Demand Control OC6

Industry Technical Code Group

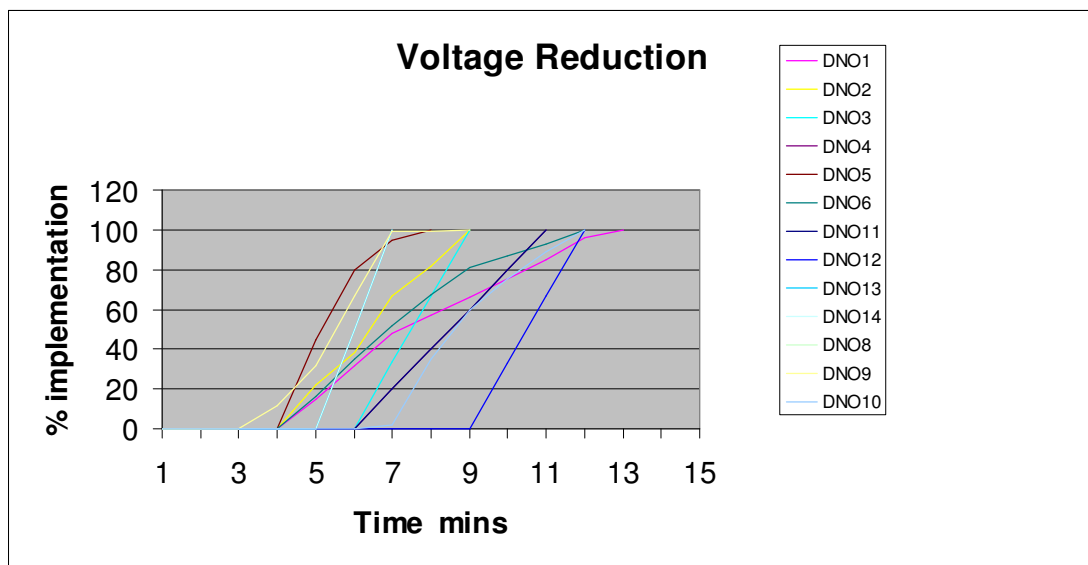
8. The results show that the demand reduction associated with a 3% voltage reduction is variable and could be as low as 2.6%; it might be more reasonable to assume from an operational management perspective that a 3% voltage reduction is more likely to result in a 3% demand reduction rather than the 5% that has been historically assumed.
